**From:** Prenosil, John  
**Sent:** Tuesday, March 1, 2022 9:00 AM  
**To:** Croteau, Nicole  
**Subject:** Re: 45 Greenwich Plains Road (John Soper) Solar Preliminary Subdivision Plan

# MEMO

RE: plans entitled: Preliminary Subdivision Plan, Fieldstone Commons, 45 Greenwich Plains Road

# PRELIMINARY SUBDIVISION PLAN FIELDSTONE COMMONS

### Sheet C 2.0

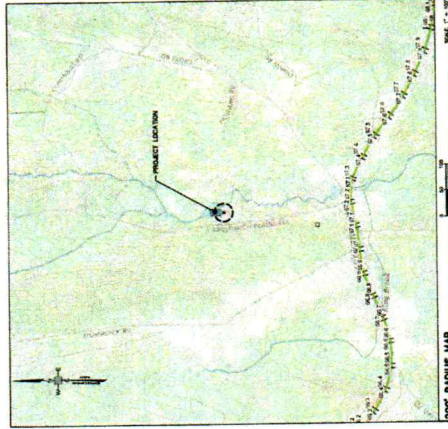
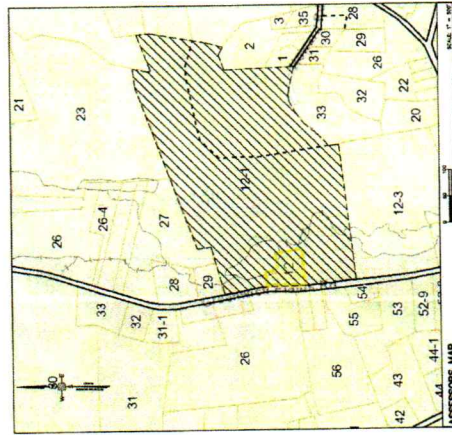
1. Would suggest including a reference plan (maybe not part of the set but maybe of the "Definitive Plans") to reference the proposed lot lines to the proposed solar array layout, to verify if the array layout conforms to setback requirements of the new parcel lines.

2. The name of the road is incorrect – should be corrected by removing the word "Old"
3. The existing house (#45 Greenwich Plains Rd) appears to be in the proposed set back lines including the septic and garage being on proposed Lot 1 and within the proposed roadway. This would create the house at 45 Greenwich Plains Road a non-conforming structure. Should consider updating proposed lot lines.

4. Will the applicant be creating an easement for the house owned by John S. Majocka, ET UX at the end of Howard Road?
5. The signature block note should be revised by removing the word "Not". The proposed lots are under the approval of the Subdivision Control Law.

6. The record owner's address is not the same as referenced on sheet C 1.0.
7. Under the "General Notes" section, reference No 1. has a spelling error of "Greenwitch" – should be corrected to: Greenwich Plains Road.

8. Under the same General Note, No 1, the note references a lot size of 80.56 acres. The purpose of the plan should be clarified. Such as "Combining the lots 12 & 12-1 to then create 3 parcels and roadway."

9. The tax map referenced in the title block should be revised to include both parcel id's, not just the lot #s.
10. The PLS number should be updated under the Surveyor's signature

11. The cover letter provided from Bertin Engineering should be addressed to the Planning Board, not the Conservation Commission.
12. The revision number in the title block should be updated to reflect the revision list Revision #1
13. What is the proposed roadway name?
14. What is the total area of the roadway? When adding Lot 1, 2, 3 & roadway areas, does it equal the 80.56 acres as stated in General Notes No 1?

1. Since DEP File Number 317-0454 has a Superseding Order of Conditions issued by DEP, will the applicant need to submit to DEP for the subdivision approval?
2. Was the proposed roadway approved under the DEP File No. 317-454, being in the exact same location & size?
3. According to the Assessor's, one of the existing parcels is classified as "Chapter land", at what point during the approval process will the landowner be filing the proper paperwork and following the protocol for removing the parcel from Chapter title?
